Informational Maps and Summary of Record Plats for the Planning Board

Agenda for January 10, 2008

PLAT NO. 220062420

Highland Park

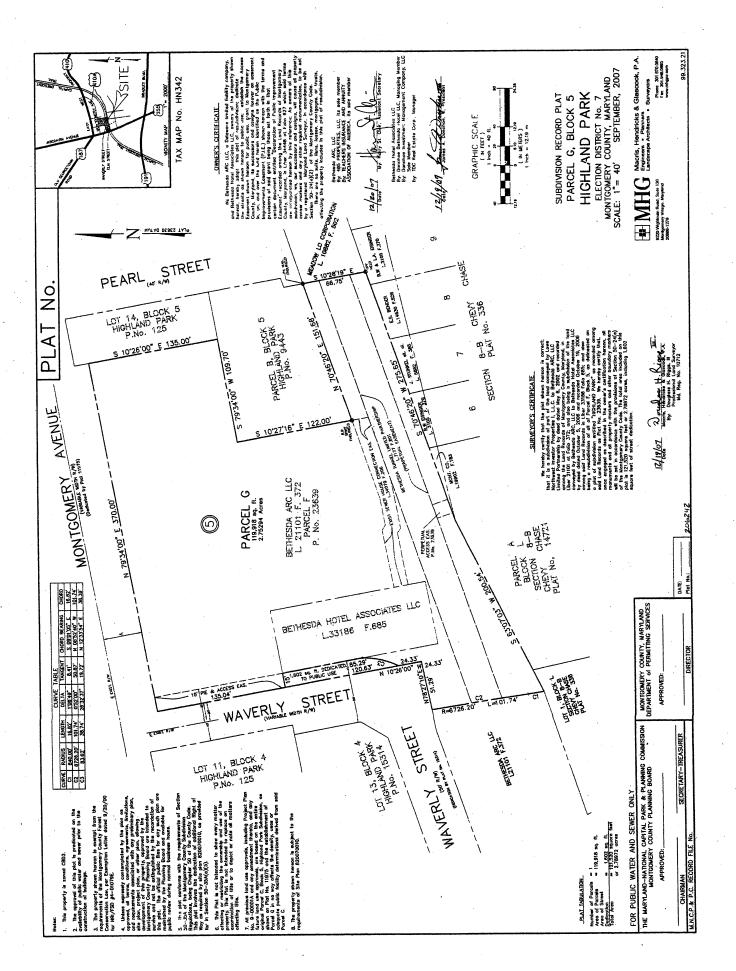
Staff recommends approval of the this minor subdivision plat pursuant to Section 50-35A(a)(5), which states as follows:

Staff applied the above-noted minor subdivision criteria for this property and concludes that the proposed subdivision complies with the criteria of Section 50-35A(a)(5) of the subdivision regulations, and with the conditions required by Site Plan No. 820070010, as approved by the Board, and supports this minor subdivision record plat.

Note: The attached site plan has been reviewed by staff, but is not signed by Development Review Chief, Rose Krasnow. Staff will ascertain all of the appropriate signatures on the certified site plan, prior to requesting Chairman Hanson's signature on the record plat.
